VILLAGE OF ORLAND PARK

Committee of the Whole

[2019-0282](#) Megan Nicole Ridge - Development Petition for Site Plan, Landscape Plan, Rezoning, Subdivision, Variance (subject to Annexation)

File Number: **2019-0282**
Orig. Department: **Development Services Department**
File Name: **Megan Nicole Ridge - Development Petition for Site Plan, Landscape Plan, Rezoning, Subdivision, Variance (subject to Annexation)**

MEGAN NICOLE RIDGE SUBDIVISION
 132ND & 88TH AVENUE, ORLAND PARK, IL
 GEOMETRIC PLAN

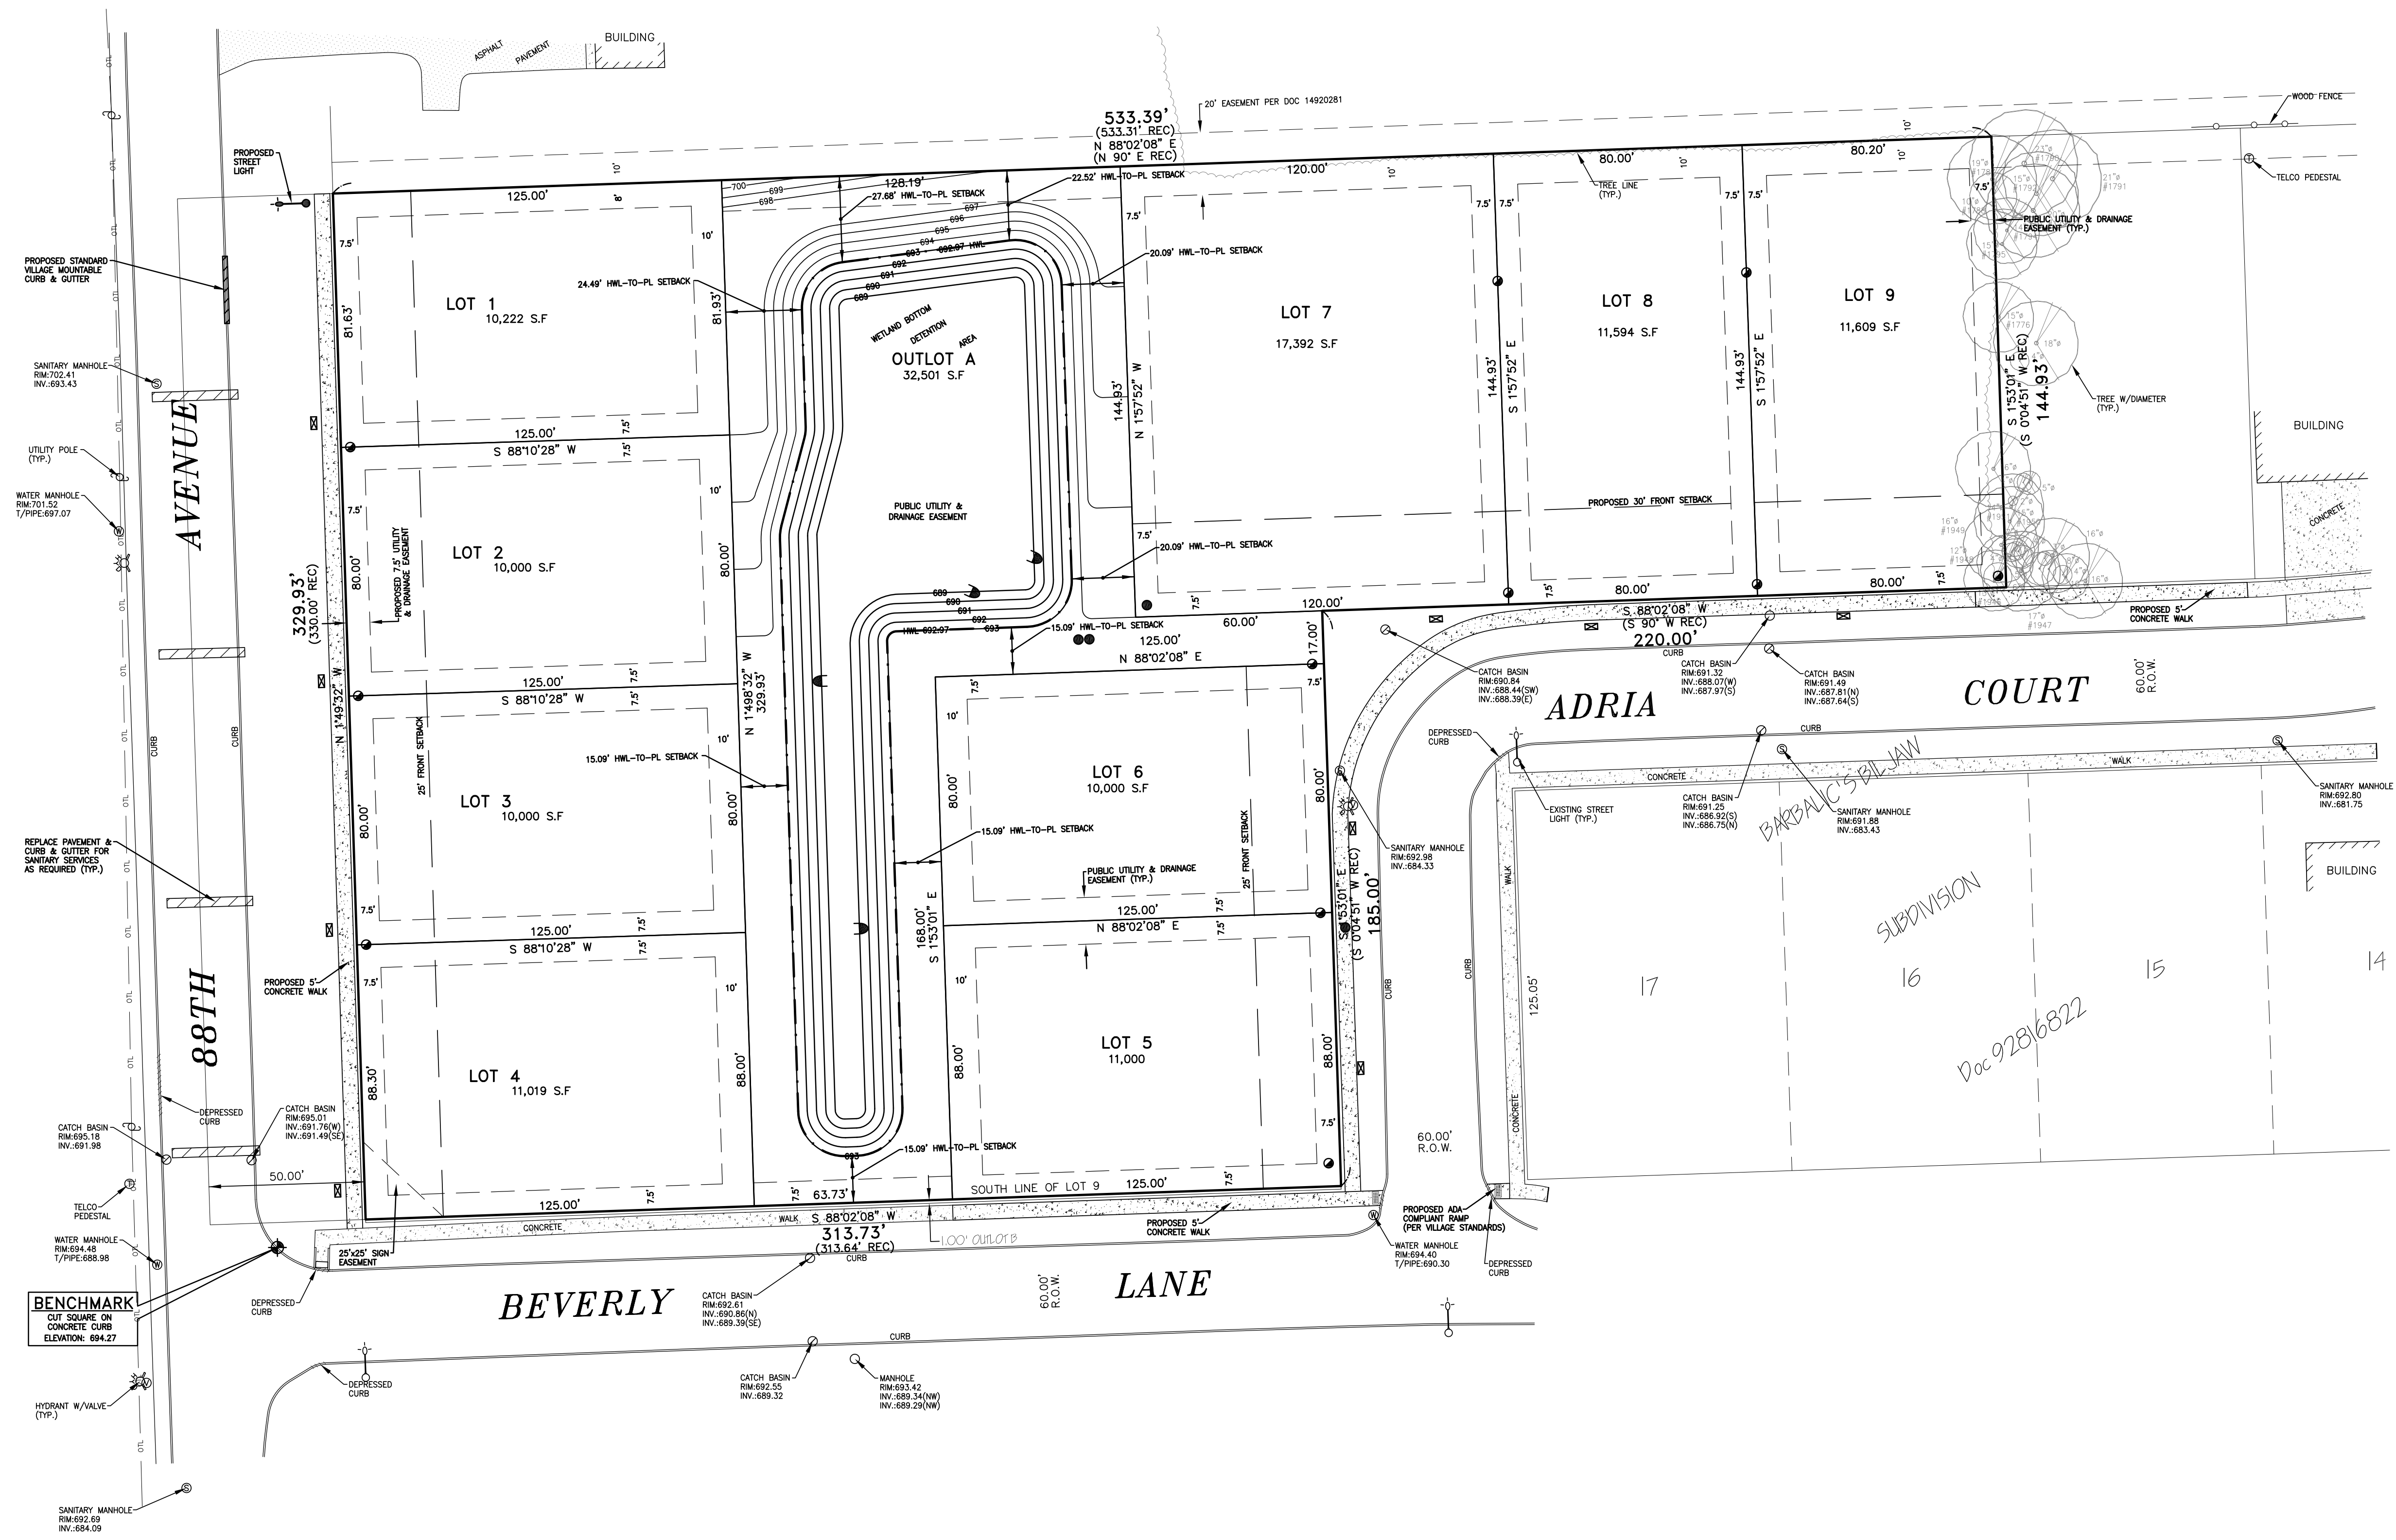
Previously, the detention pond setback variance was proposed to be as little as 15.57 feet at certain locations. Under the revised plans, the setback is now proposed to be as little as 15.09 feet in certain locations, particularly along the south leg of the pond. The setbacks along the north side of the pond range from 27.68 feet to 22.52 feet (previously 28.16 feet to 23.43 feet proposed). The northeast side of the pond has a proposed setback of 20.09 feet (previously 15.57 feet to 20.14 feet), while the northwestern side of the pond has a proposed setback of 24.49 feet (previously 19.97 feet). A portion of the north side of the pond meets setback requirements, with a 27.68 foot setback proposed.

Commissioner Zaatar asked if the petitioner explored reducing the size of Lot 7, moving Lot 7 to the east, combining Lot 8 or Lot 9, or exploring other alternatives to reduce the need for the pond setback variance. The petitioner has not proposed any changes to the size of Lot 7 since the November 5, 2019, Plan Commission meeting. Staff also noted that they previously suggested that the size of Lot 7 could be reduced during the staff review process. Mr. Szkirpan stated that the lot meets code requirements and there are two oversized lots at the end of the cul-de-sac on Adria Court. The petitioner did not wish to reduce the size of Lot 7.

I move to recommend to the Village Board denial of the **Preliminary Site Plan** titled "Preliminary Site Plan for Megan Nicole Ridge Subdivision", prepared by Landmark Engineering, LLC, Sheet PSP1, dated July 8, 2019, and last revised January 15, 2020;

I move to recommend to the Village Board approval (upon annexation) of the **Preliminary Site Plan** titled "Preliminary Site Plan for Megan Nicole Ridge Subdivision", prepared by Landmark Engineering, LLC, Sheet PSP1, dated July 8, 2019, and last revised January 15, 2020, subject to the following conditions:

PRELIMINARY SITE PLAN FOR MEGAN NICOLE RIDGE SUBDIVISION

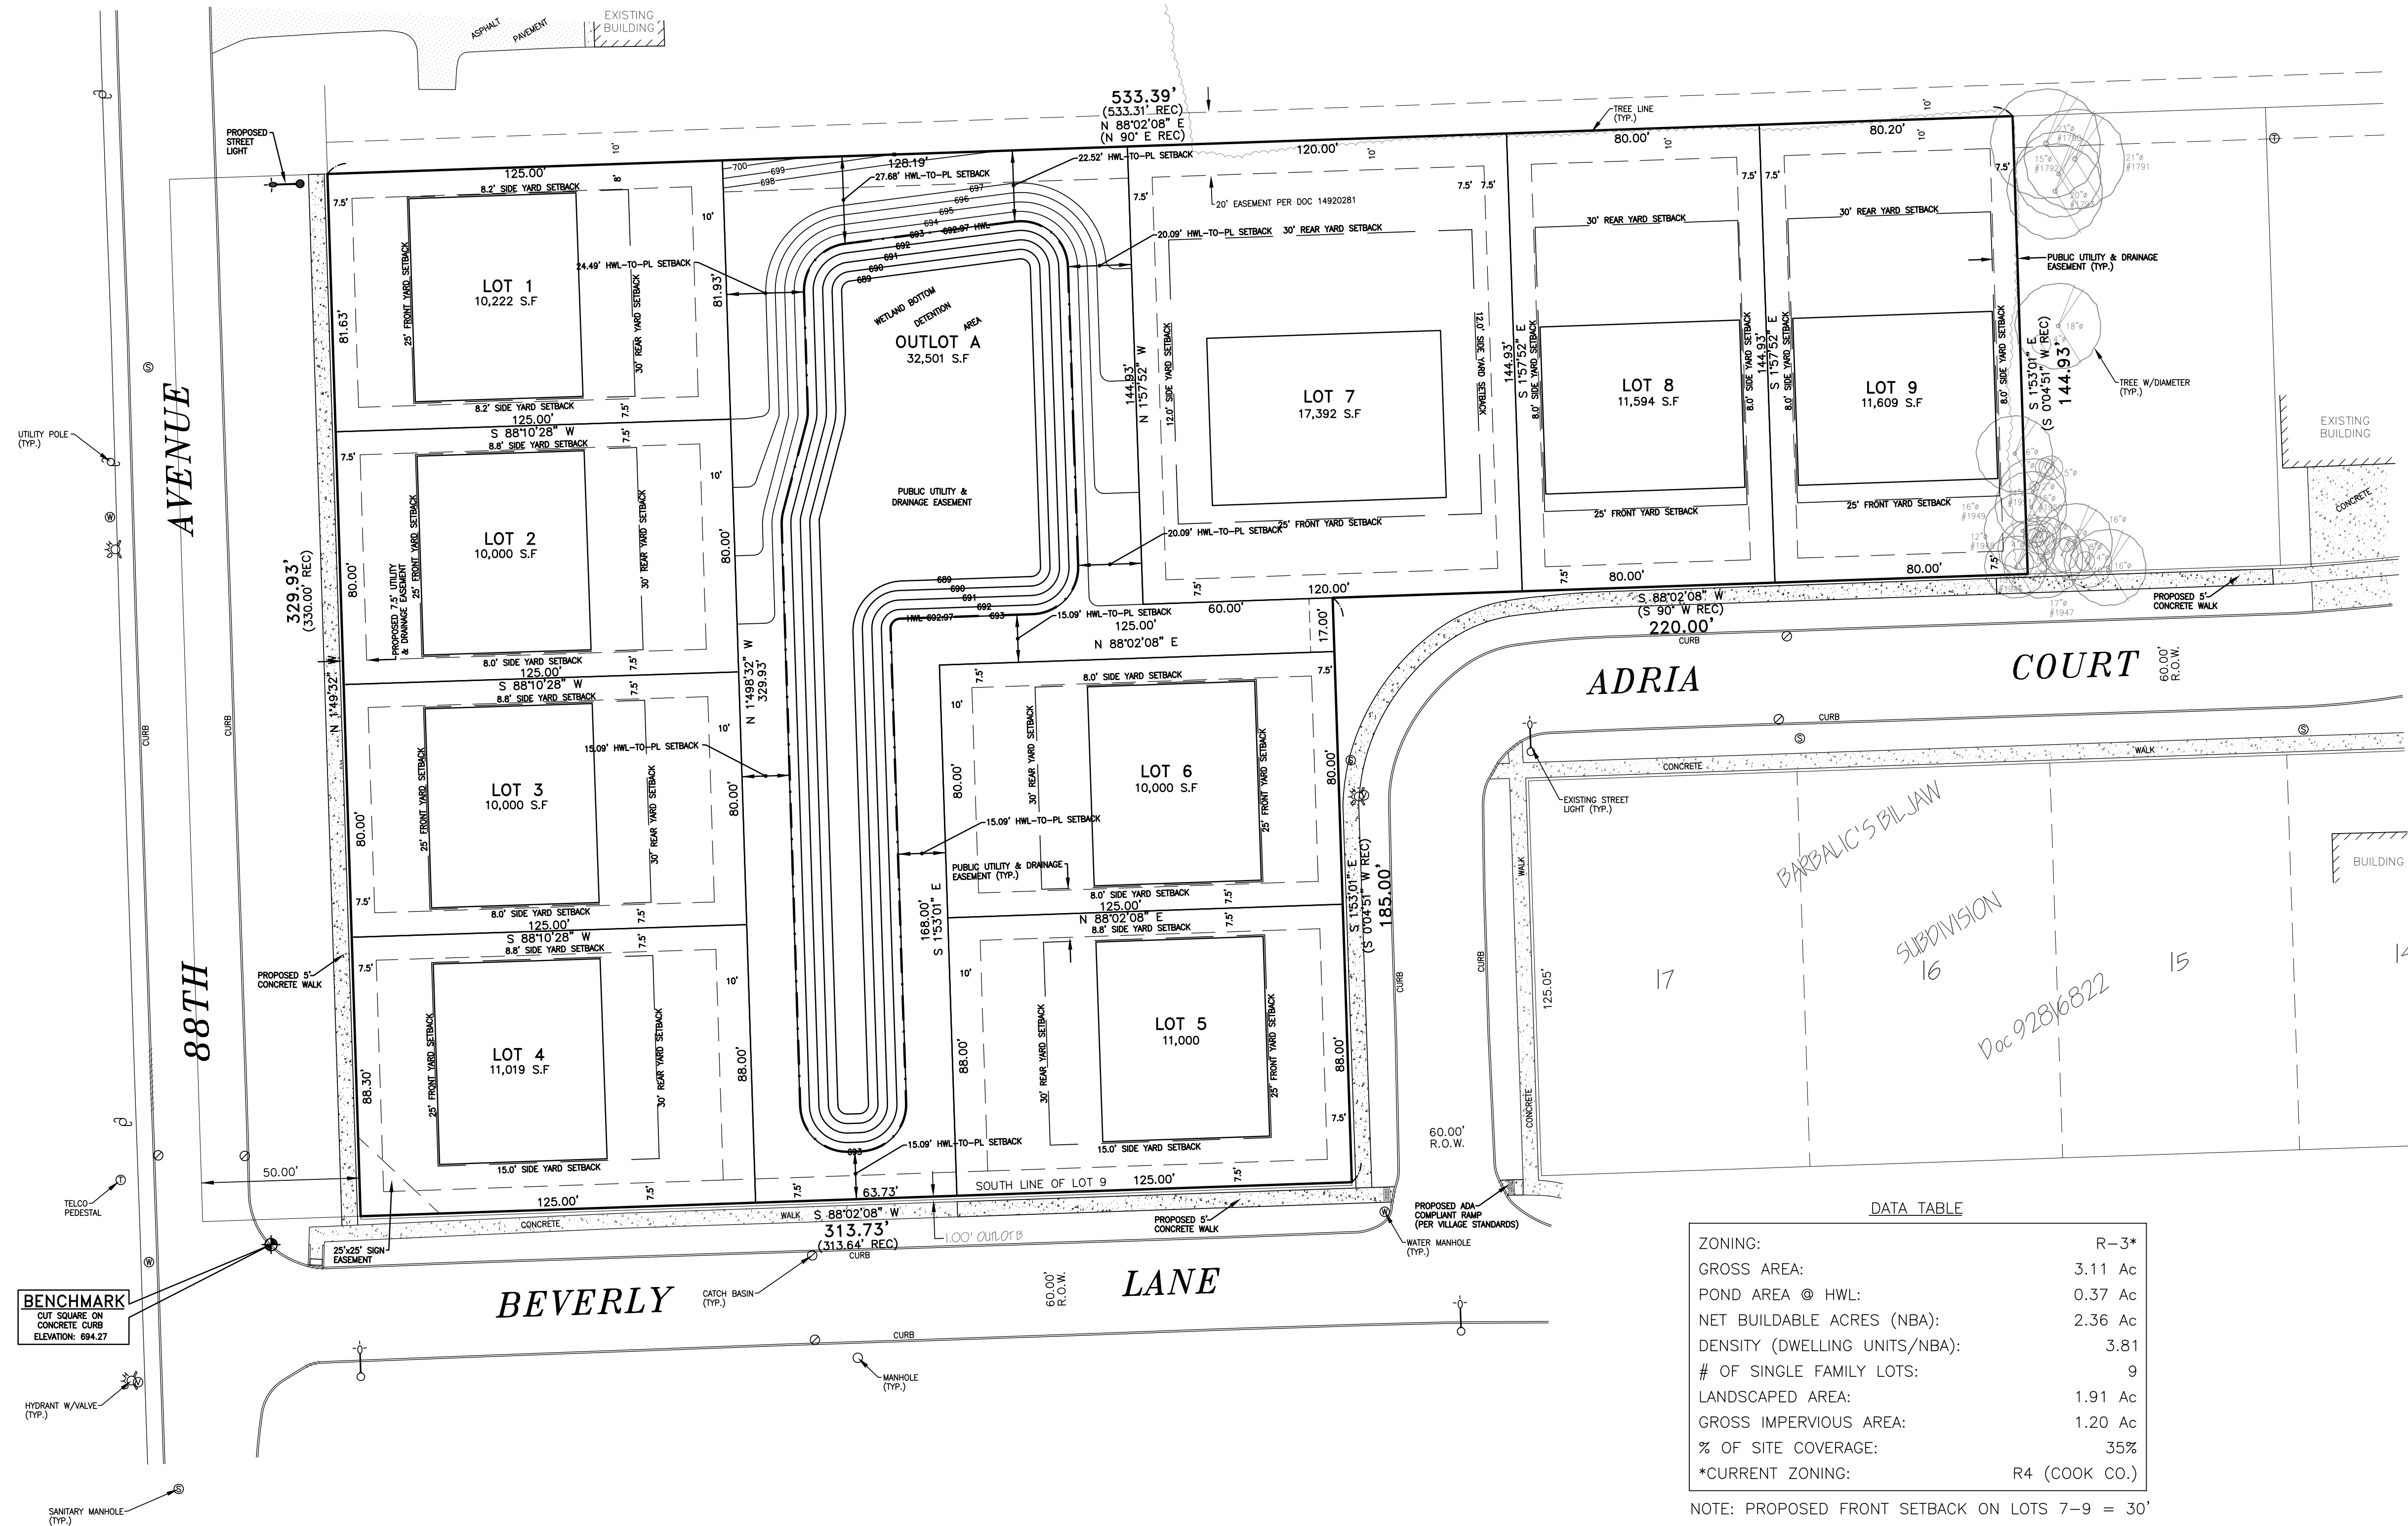
As noted above, since the project was presented at the November 5, 2019 Plan Commission meeting, the petitioner has incorporated the 10 foot by 144.9 foot property (PIN 23-35-300-041) into the subdivision plans. As a result, the overall size of Outlot A has increased from 31,052 square feet to 32,501 square feet, and the total size of the proposed subdivision has increased from 3.07 acres to 3.11 acres.

The petitioner is also proposing minor changes to the setback between the high water line of the pond and the adjacent property lines on Outlot A as a result of additional stormwater volume being included for the 10 foot by 144.9 foot property (PIN 23-35-300-041) as well as the 80 foot by 144.9 foot property (PIN 23-35-300-042), based on the recommendation at the previous Plan Commission meeting.

Previously, the detention pond setback variance was proposed to be as little as 15.57 feet at certain locations. Under the revised plans, the setback is now proposed to be as little as 15.09 feet in certain locations, particularly along the south leg of the pond. The setbacks along the north side of the pond range from 27.68 feet to 22.52 feet (previously 28.16 feet to 23.43 feet proposed). The northeast side of the pond has a proposed setback of 20.09 feet (previously 15.57 feet to 20.14 feet), while the northwestern side of the pond has a proposed setback of 24.49 feet (previously 19.97 feet). A portion of the north side of the pond meets setback requirements, with a 27.68 foot setback proposed.

I move to recommend to the Village Board approval (upon annexation) of the **Preliminary Site Plan** titled “Preliminary Site Plan for Megan Nicole Ridge Subdivision”, prepared by Landmark Engineering, LLC, Sheet PSP1, dated July 8, 2019 and last revised January 15, 2020, subject to the following conditions:
